Access Compliance Report

Public Rights-of-Way

Intersection ID: 50904	Main Street: KARRAS COMMONS_WY	Cross Street: TILLEY MORRIS_RD	Location: NW
ADA ID: 85CC23A6DB47	Ramp Type: Perp	Initial Pass/Fail: Fail	Overall Compliance: No
			Severity Score: 10

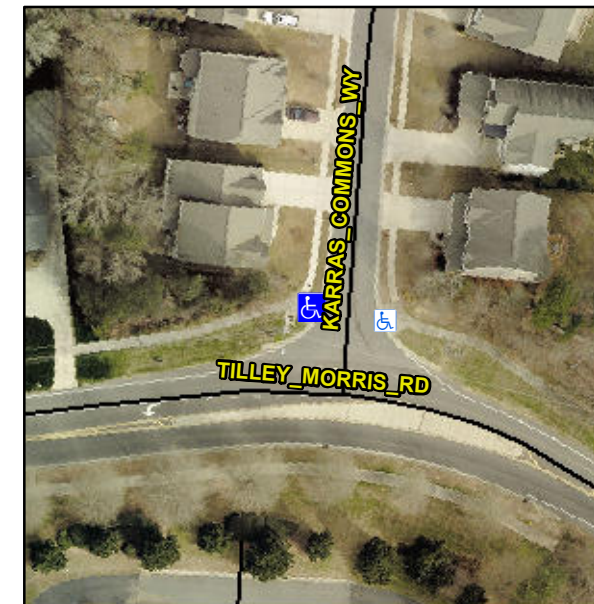
Not Found, R304.5.1, R304.5.3

Compliance	Description	Data	Compliance	Description	Data
N/A	Ramp Length (in)	88.0	Yes	Ramp Slope (%)	5.0
No	Ramp Width (in)	44.0	No	Ramp XSlope (%)	3.0
N/A	Flare Type LT	N/A	N/A	Flare Type RT	N/A
N/A	Flare Slope LT (%)	N/A	N/A	Flare Slope RT (%)	N/A
N/A	Flare Traversable LT?	N/A	N/A	Flare Traversable RT?	N/A
N/A	Landing Length (in)	N/A	N/A	DWS Provided?	N/A
N/A	Landing Width (in)	N/A	N/A	DWS Contrast?	N/A
N/A	Landing Slope (%)	N/A	N/A	DWS Length (in)	N/A
N/A	Landing X Slope (%)	N/A	N/A	DWS Full Width?	N/A
N/A	Landing Curb? (Y/N)	N/A	N/A	DWS Offset (in)	N/A
N/A	Shared Landing?	N/A			
N/A	Gutter Ponding?	N/A	N/A	Gutter Slope (%)	N/A
N/A	Gutter Lip Ht (in)	N/A	N/A	Gutter X Slope (%)	N/A
N/A	Painted X Walk1?	No	N/A	Painted X Walk2?	N/A
	X Walk 1 Direction	To E		X Walk 2 Direction	N/A
N/A	X Walk 1 Width (in)	N/A	N/A	X Walk 2 Width (in)	N/A
	X Walk 1 Slope (%)	1.3		X Walk 2 Slope (%)	N/A
	X Walk 1 X Slope (%)	3.3		X Walk 2 X Slope (%)	N/A

Remove & Replace Entire Ramp.
